## DRAWING SHEET AMENDMENTS

Three formal drawings sheets are included herewith with corrections / changes to part numbering. Please substitute each of these corrected drawing sheets with the corresponding originally filed sheet. Thank you.

FIG. 22

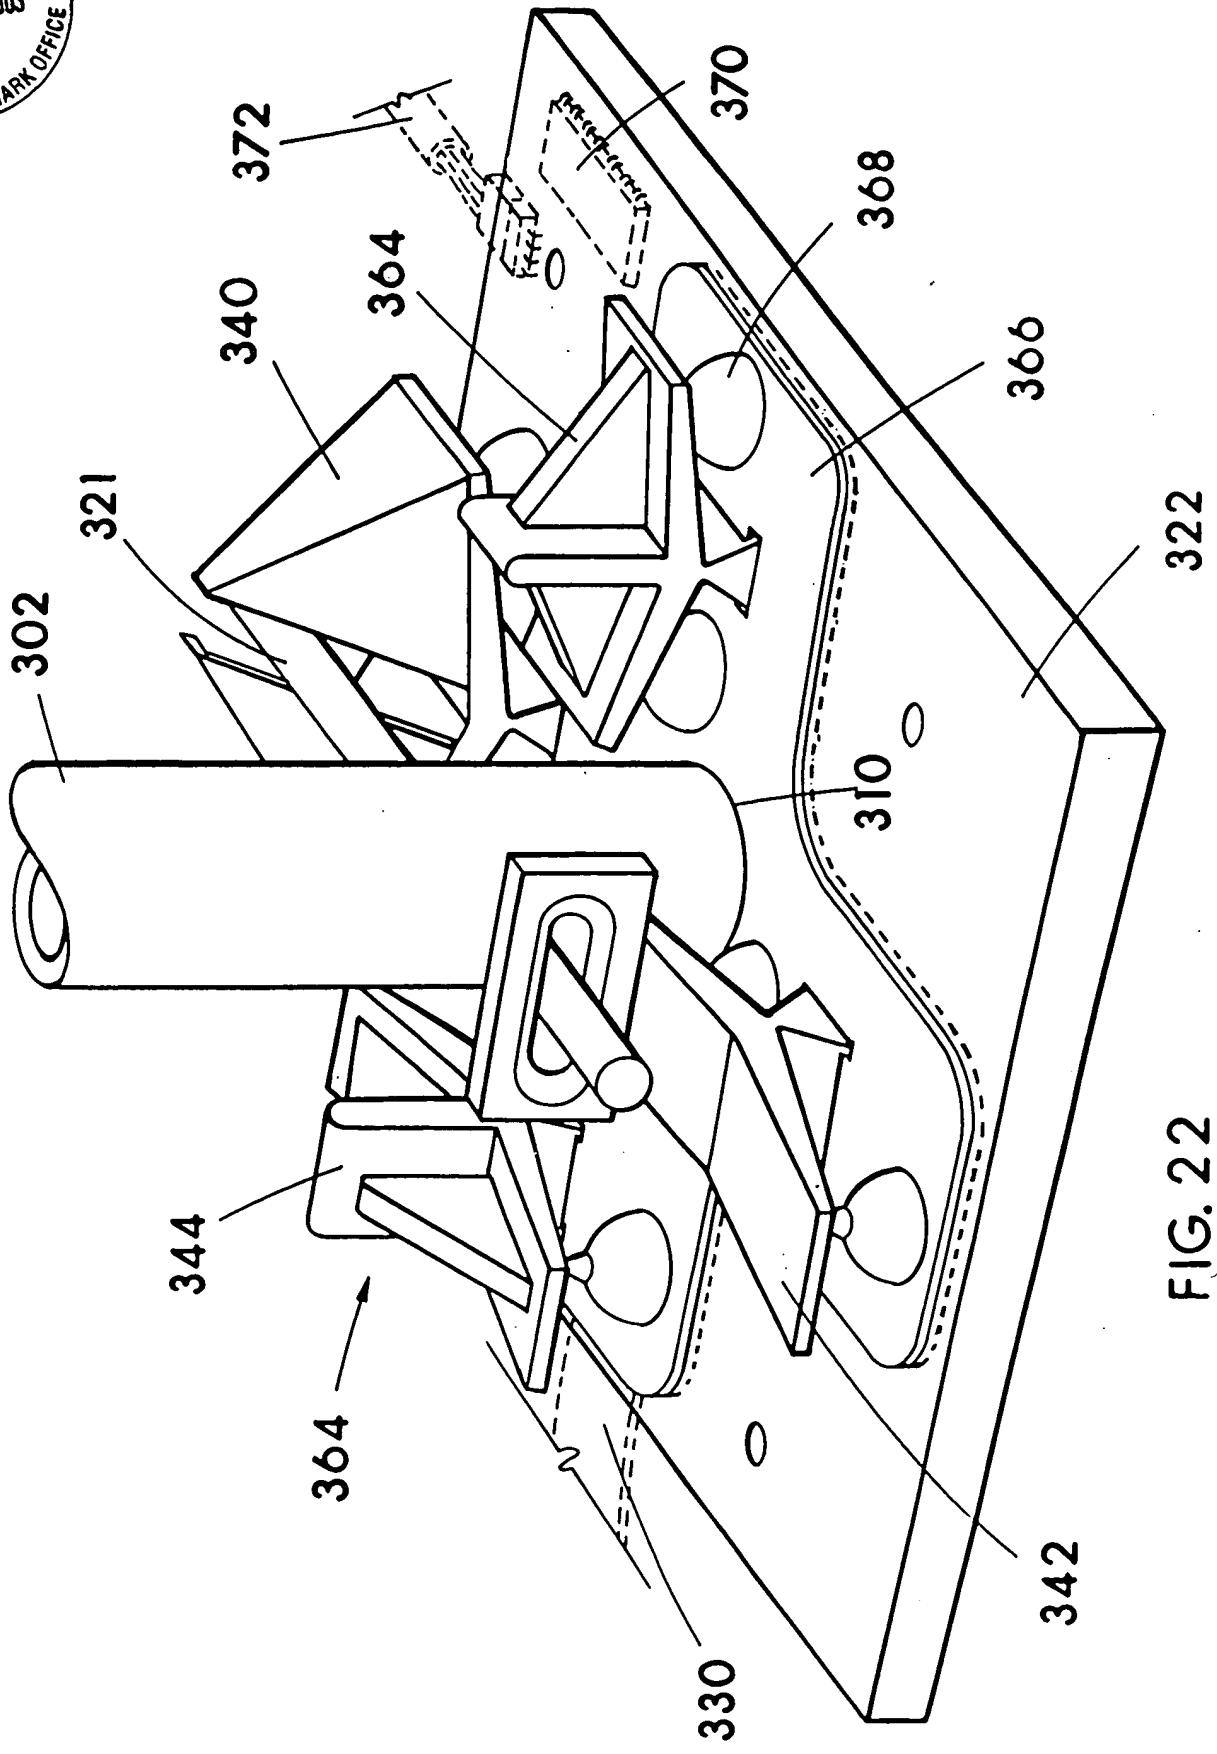
The first drawing sheet has Fig. 22 thereon. The change is that "346" on the second t-rocker has been corrected to read --364--.

FIG. 26

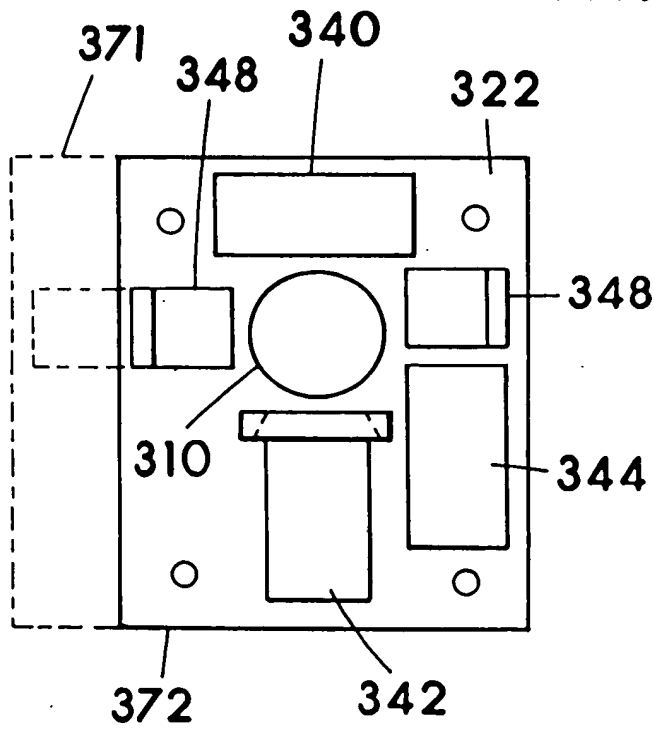
The second drawing sheet has Fig. 25, Fig. 26 and Fig. 27 thereon. The change is that "370" on the broken-line area in Fig. 26 has been corrected to read --371--.

FIG. 45

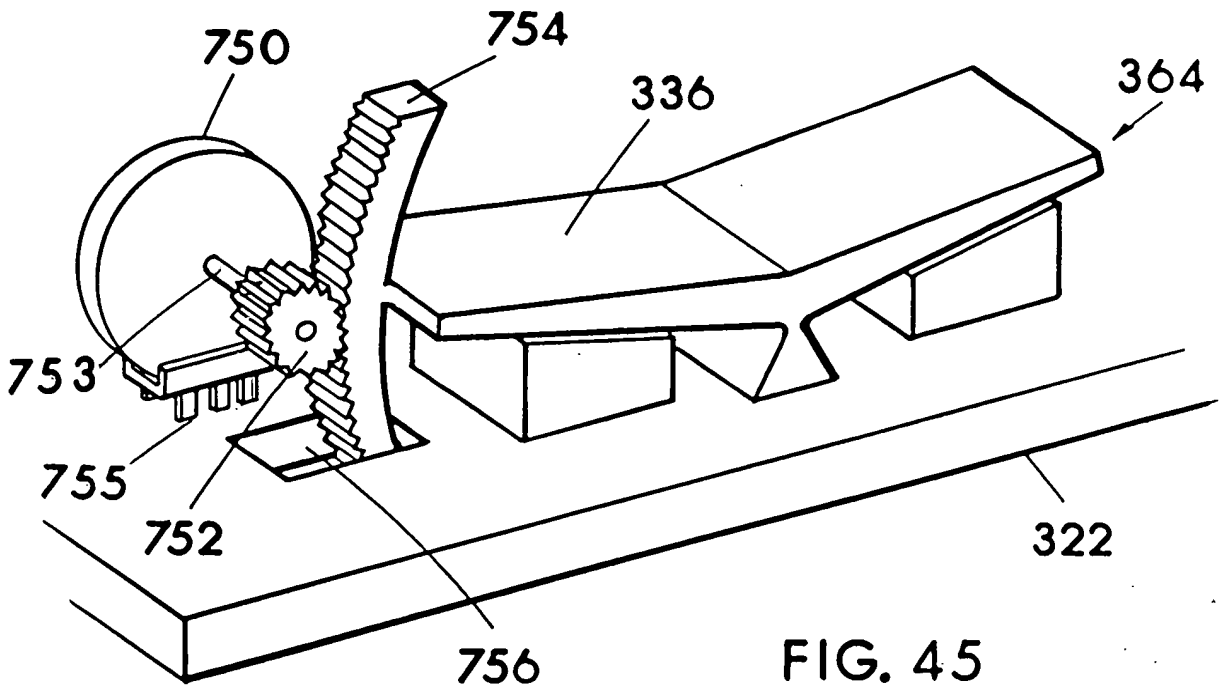
The third drawing sheet has Fig. 45 and Fig. 46 thereon. In Fig. 45 the number "753" and an indicator line have been added to the originally shown shaft of the rotary sensor 750. Also in Fig. 45 is the number "755" and an indicator line has been added to the originally shown terminals or solder tangs of the same sensor 750. The part numbers 753 and 755 have also been added to the specification language by amendments shown below.
